CALVERT CLIFFS  
NUCLEAR POWER PLANT

**SUBJECT:** Calvert Cliffs Nuclear Power Plant  
Independent Spent Fuel Storage Installation; Docket No. 72-8  
Response to Second Request for Additional Information for Renewal Application  
to Special Nuclear Materials License No. 2505 for the Calvert Cliffs Site Specific  
Independent Spent Fuel Storage Installation

**SECOND REQUEST FOR ADDITIONAL INFORMATION FOR  
RENEWAL APPLICATION**

Figure 1 – Heat Loads of Currently Loaded DSCs During the Initial and Extended ISFSI License Period

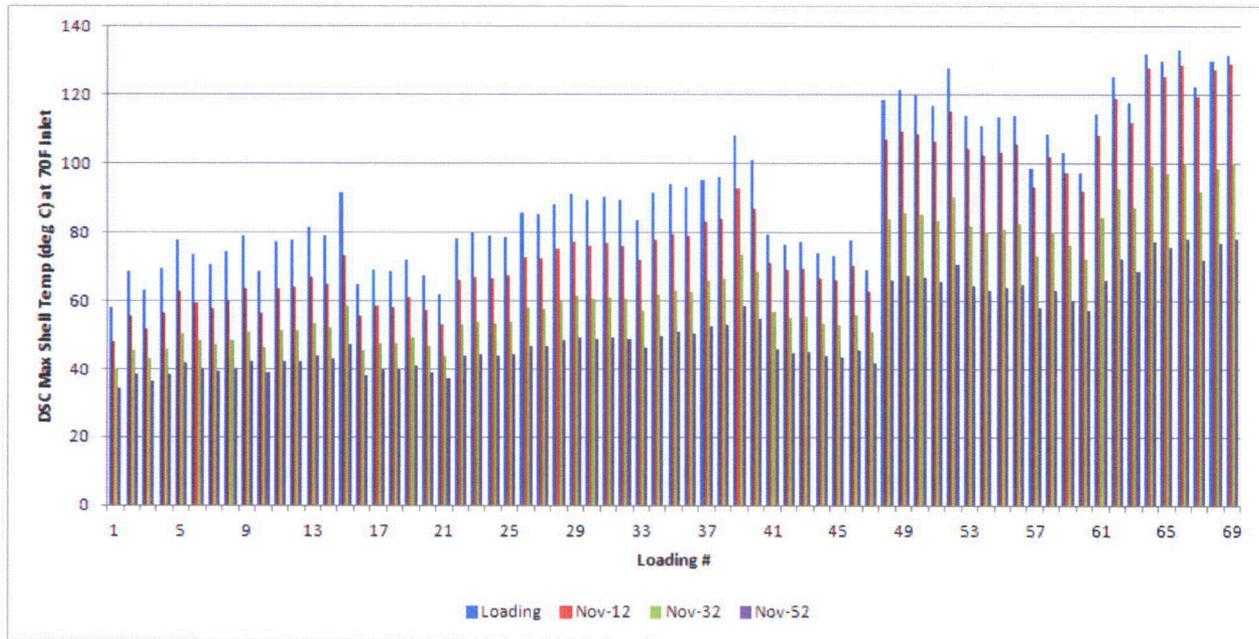
*Provide justification that no welds or cask surfaces currently have or will have a temperature of  $\leq 85^{\circ}\text{C}$  over the next 40 years, at temperatures bounded by normal conditions of storage. If the surface temperature decreases below  $85^{\circ}\text{C}$  at conditions in which the stainless steel components are susceptible to stress corrosion cracking, justify why the planned inspections are adequate to detect potential degradation as a result of stress corrosion cracking.*

*NUREG/CR-7030, "Atmospheric Stress Corrosion Cracking Susceptibility of Welded and Unwelded 304, 304L, and 316L Austenitic Stainless Steels Commonly Used for Dry Cask Storage Containers Exposed to Marine Environments" reports that stress corrosion cracking and pitting corrosion of 304 and 316 stainless steel may occur at temperatures less than  $85^{\circ}\text{C}$  in bounding relative humidity environments.*

Figure 1 below provides the initial and estimated heat loadings of all currently loaded DSCs during the current and extended ISFSI license period. The heat load by assembly in each canister was adjusted from the time of loading for decay to each of the future dates shown using the equation given in Reference 2 (page 132). To provide some sense of when these DSCs will fall below the  $85^{\circ}\text{C}$  temperature threshold discussed in RAI O-6, an estimate of DSC surface temperature was developed. The best information available currently comes from design basis calculations which determine the maximum DSC shell surface temperature (DSC top center) for comparison against design limits. Those calculations give a maximum shell surface temperature of  $144^{\circ}\text{C}$  for a 21.12 kW NUHOMS-32P DSC (Reference 3, page 11) and  $121^{\circ}\text{C}$  for a 15.84 kW NUHOMS-24P DSC (Reference 4, Table 8.1-12), when stored inside an HSM with  $70^{\circ}\text{F}$  ( $21^{\circ}\text{C}$ ) inlet air temperature. These two maximum temperature points were trended with a nominal 0 kW canister with a  $21^{\circ}\text{C}$  surface temperature. The resulting trend ( $T(h) = -0.0947 h^2 + 7.8125 h + 21.111$ ; where  $h$  is DSC heat load in kW) was then used to develop the estimate of the maximum surface temperatures of each DSC by heat load shown in Figure 2 (lower temperatures would be expected at the bottom and ends of the DSC). The results suggest that many of the earliest canisters loaded have spent most of their time in storage below  $85^{\circ}\text{C}$ .

For those DSCs for which the surface temperature has or is projected to fall below  $85^{\circ}\text{C}$  over the next 40 years Calvert Cliffs is investigating the possibility of accumulation of salt on the surface of DSCs via a deliquescence process in the sheltered ISFSI environment. Without such accumulation there is no concern that SCC has occurred. Specifically, Calvert Cliffs has volunteered to be a lead plant for an industry initiative with Electric Power Research Institute, Nuclear Energy Institute, and other utilities for the purpose of determining susceptibility to SCC identified by NUREG/CR-7030. Field inspection data
